SUBJECT: HOPE CREEK INDEPENDENT DESIGN VERIFICATION PROGRAM (IDVP)
OBSERVATION REPORTS

Public Service Electric and Gas Company
Hope Creek Generating Station - Unit 1

Independent Design Verification Program
Observation Reports

As Shown on Drawing

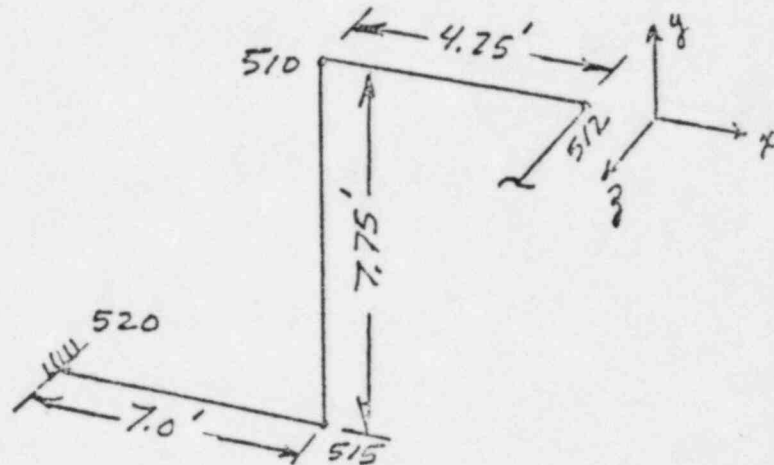
1. Structure(s), system(s), or component(s) involved:
Calculation No. C-1750-3Q, dated 2/13/84, Safety Auxiliary Cooling System Piping.
2. Description of Observation:
In calculation C-1750-3Q, the computer model of line 155-HBC-30, from node 512 through node 520 does not appear to agree with the routing shown on drawing HG-1-P-EG-13, Revision 10D, dated 2/1/84.
(continued on next page)

In the computer analysis, the line is modeled as a span of 4.25 feet from node 510 north to node 512 (X direction), followed by a span of 7.75 feet downward to node 515, followed by a seven foot span north to the anchor at node 520.

Drawing HG-1-P-EG-13 shows a downward span of twelve feet from nodes 510 to 515, followed by a span of seven feet north to the anchor at data point 520 with no 4.25 foot span in the X direction from node 510.

4. Recommendation for resolution (optional):
 - a. Provide justification that the discrepancy in the computer model has been reconciled with the design drawing.

- b. Provide assurance that other piping stress analyses have been reconciled with the design drawings.
5. Internal Review Committee classification of Observation:
 Not significant to safety (See Item 6)
 x Additional information required (See Item 6)
 Potentially Significant to Safety (See Item 8)
